STATE OF CONNECTICUT
CONNECTICUT SITING COUNCIL

IN RE: :
 :
A PETITION OF CELLCO PARTNERSHIP D/B/A : PETITION NO. 1616
VERIZON WIRELESS FOR A DECLARATORY :
RULING ON THE NEED TO OBTAIN A SITING :
COUNCIL CERTIFICATE FOR THE :
MODIFICATION OF AN EXISTING :
TELECOMMUNICATIONS FACILITY AT 194 :
MOUNT PARNASSUS ROAD, EAST HADDAM, :
CONNECTICUT : JUNE 6, 2024

**RESPONSES OF CELLCO PARTNERSHIP D/B/A VERIZON WIRELESS TO
CONNECTICUT SITING COUNCIL INTERROGATORIES**

Comparative Viewshed Analysis Map

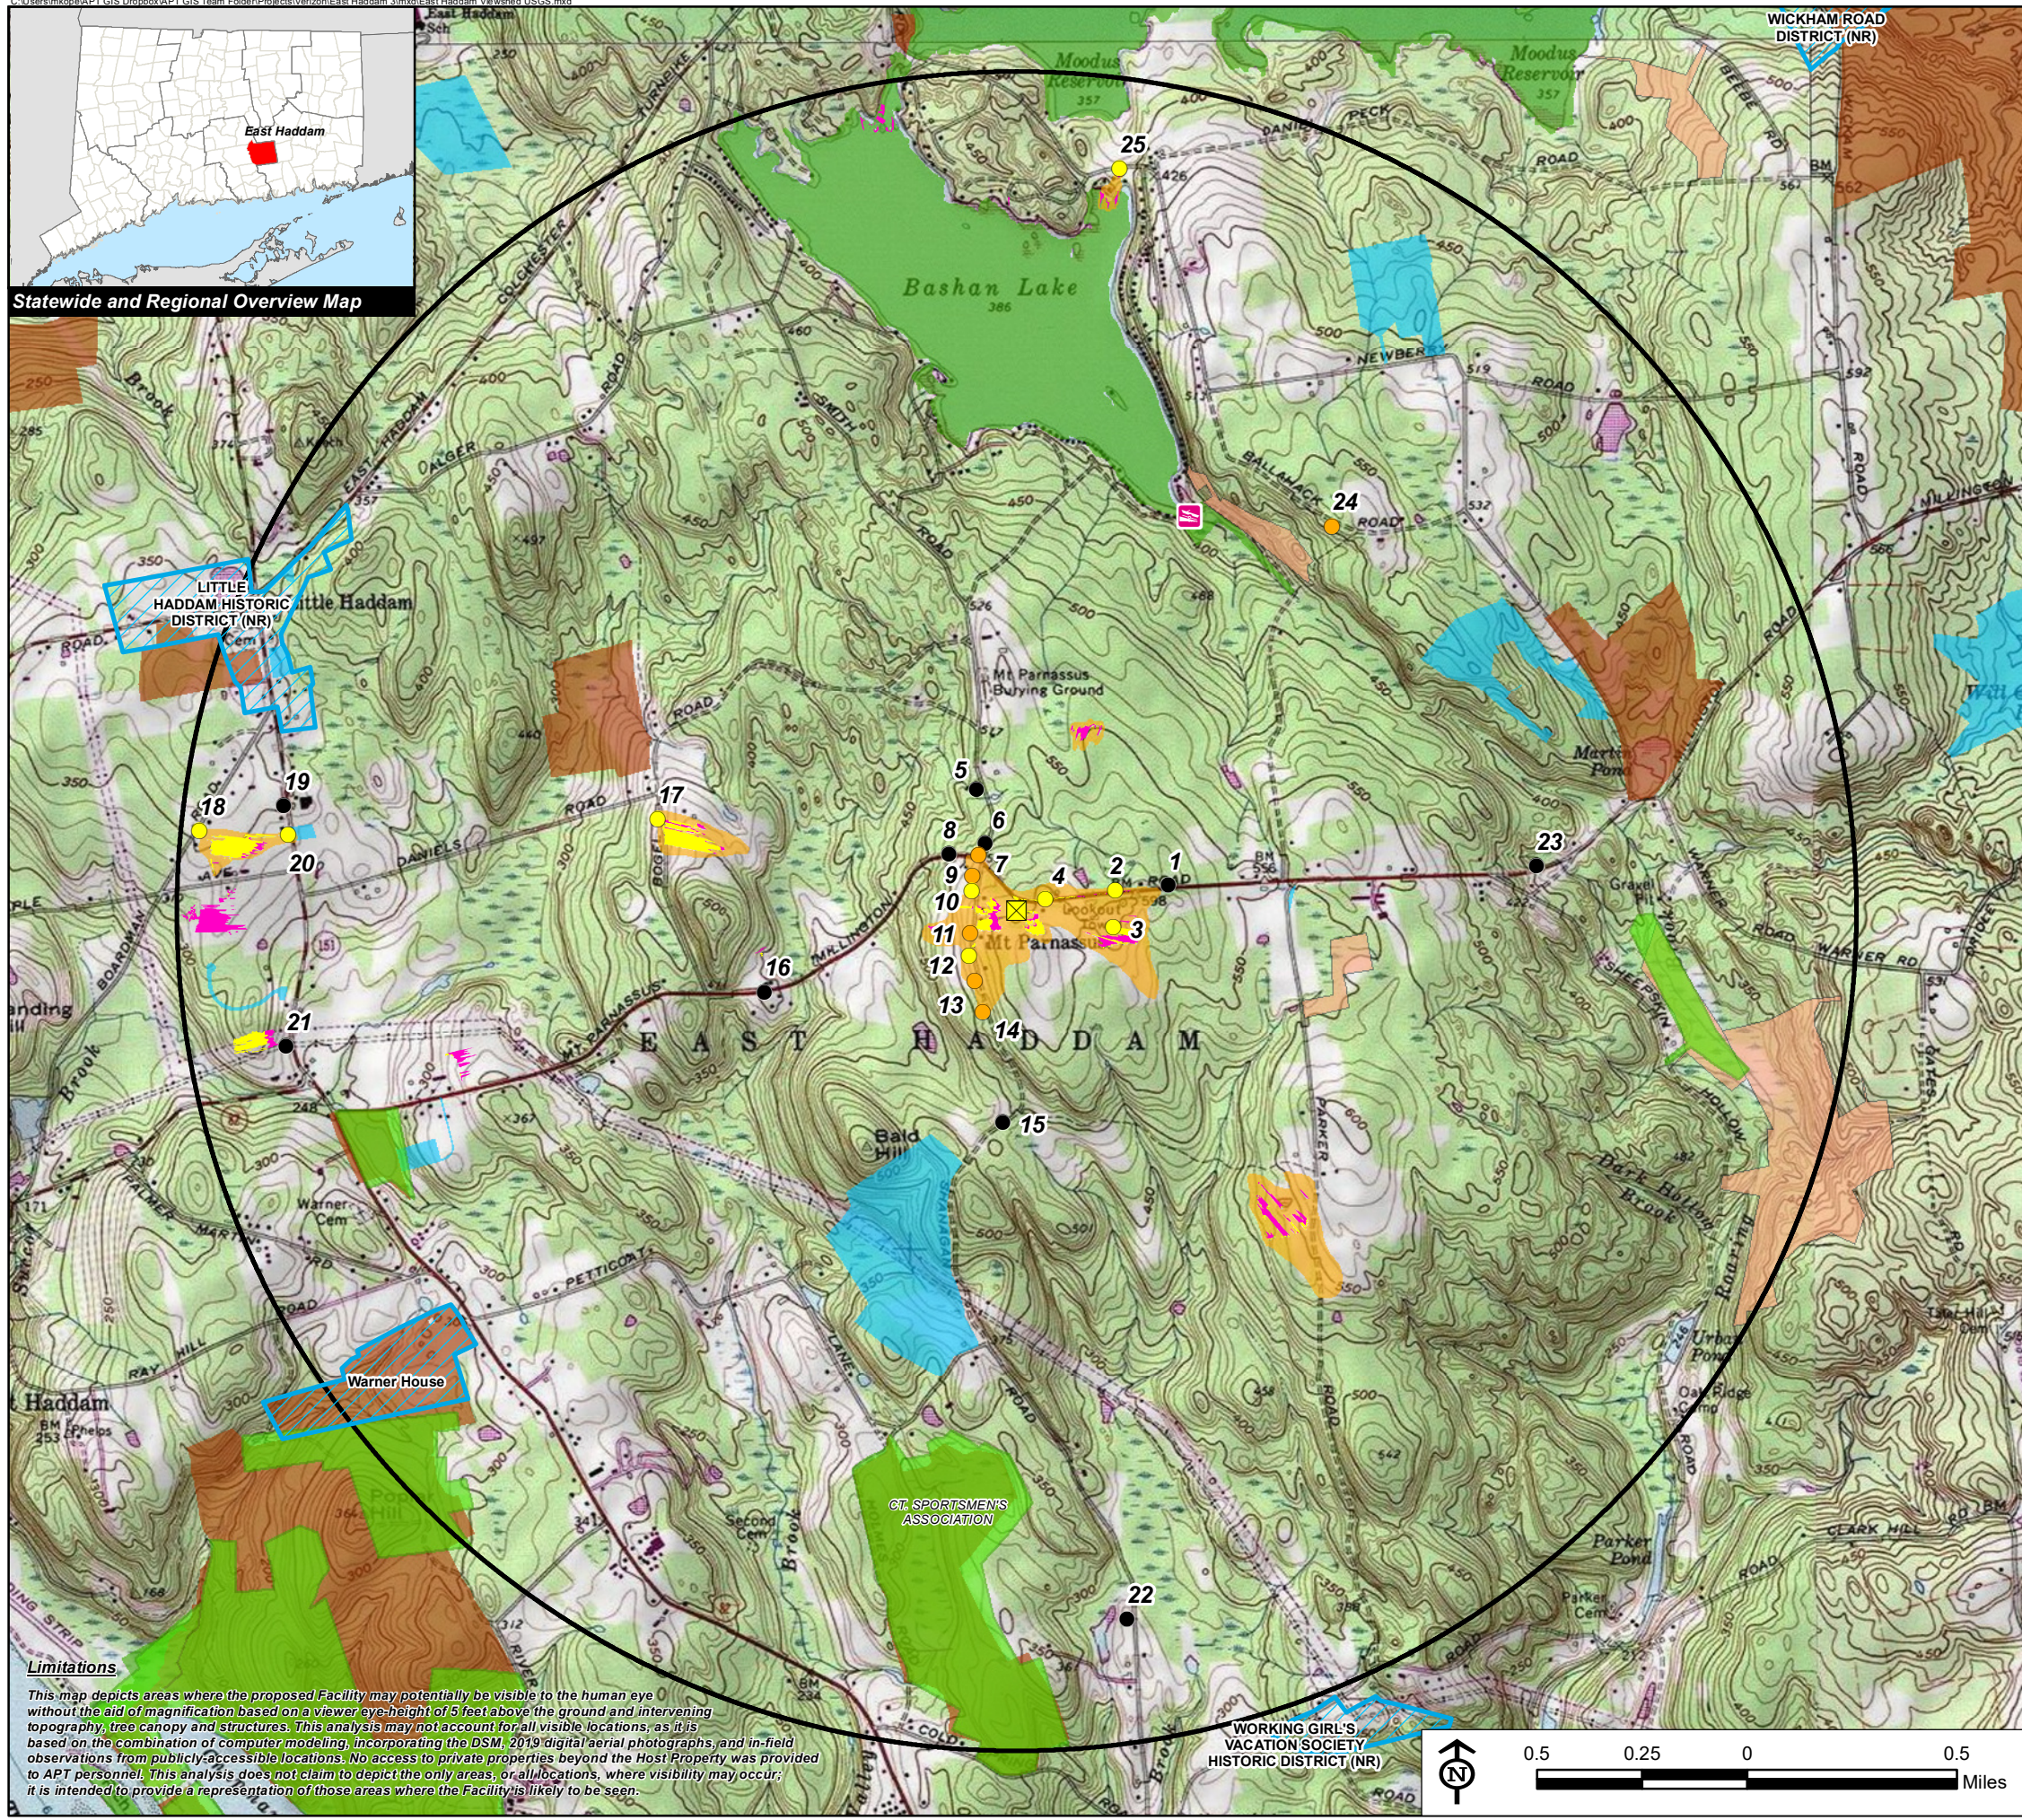
Referencing Petition Attachment 6, the maps on the last two pages are cutoff. Please re-submit the maps on larger sized paper.

Referencing Petition Attachment 6, characterize the change in visibility of the proposed extended facility versus the existing facility in the immediate and surrounding area.

Full size viewshed maps are included in Attachment 3.

The change in visibility of the proposed extended facility tower versus the existing facility in the immediate and surrounding area can best be characterized as minor, with a shift to what are primarily seasonal views to a greater mix of seasonal and year-round views. As noted in the conclusion to the Visibility Analysis (Petition - Attachment 6), the existing facility is visible today primarily within 0.25-mile or less of the site. The proposed 40-foot extension of the tower will make the facility more prominent in some locations, particularly where the current facility is visible through intervening vegetation today, as it will rise farther above the tree line. Photos 2 and 4, and their corresponding simulations, provide examples. Notably, no new areas of visibility are created by the proposed extension.
